RESPONSE TO REQUEST FOR ADDITIONAL INFORMATION

US-APWR Design Certification

Docket No. 52-021

RAI NO.: NO. 960-6709 REVISION 4
SRP SECTION: 03.07.02 – Seismic System Analysis
APPLICATION SECTION: 3.7.2
DATE OF RAI ISSUE: 09/24/2012

Figure 1. Displacement difference between decoupled and coupled analysis versus T_s/T_m , for $k_y = 0.2$ (modified after Figure 10c of Reference 7)

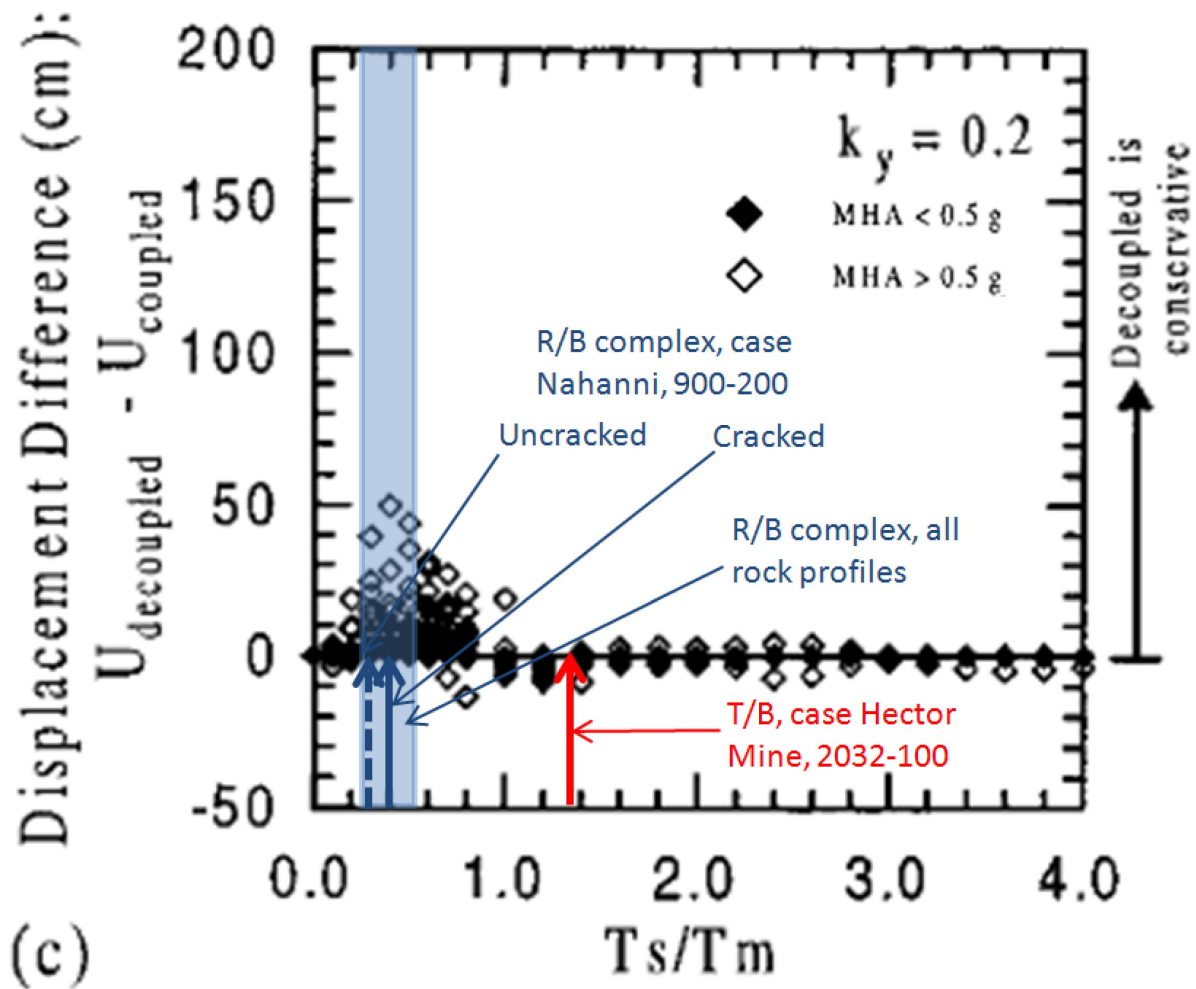
b) In Section 4.1, under Assumption number 2, the applicant indicated that it is assumed that a small amount of sliding will not modify the ground motion in the vicinity of the basemat. The applicant is requested to provide a quantitative measure of "small amount of sliding." The applicant also stated that, "this assumption is the accepted industry practice for such analyses." The applicant is requested to provide appropriate basis and references to demonstrate the industry practice for such analyses and that it has been accepted by the staff.

Figure 1 shows the differences between coupled and decoupled analysis results obtained in the parameter study presented in Reference 7 as a function of the ratio between the dominant period of the structure and the dominant period of the seismic input motion. The markers relevant for US-APWR are the full markers, corresponding to maximum horizontal accelerations (MHA) smaller than 0.5g. For the parameters corresponding to the R/B complex (and indicated by blue arrows) all the results in the parameter study indicate that the decoupled analysis is conservative (i.e., the sliding calculated in a decoupled analysis, $U_{\text{decoupled}}$, is larger than the sliding calculated in a coupled analysis, U_{coupled}). For the parameters corresponding to the T/B the difference between coupled and decoupled analysis results is about zero.

For the R/B complex, the parameters relevant to the study and used in Figures 1 and 2 (namely k_y/k_{max} and T_s/T_m) have been calculated for all subgrade profiles and all input acceleration time histories. The ranges of these parameters for the rock profiles (900-200, 900-100 and 2032-100) that dominate sliding are indicated in Figures 1 and 2 by blue shaded areas, and are:

- Between 0.52 and 0.64 for k_y/k_{max}
- Between 0.24 and 0.47 for T_s/T_m

The comparisons presented in Figures 1 and 2 support the conclusion that, for the range of parameters used in the MHI sliding analyses, the decoupled method provides similar or slightly conservative results in terms of sliding as compared to the fully coupled method.
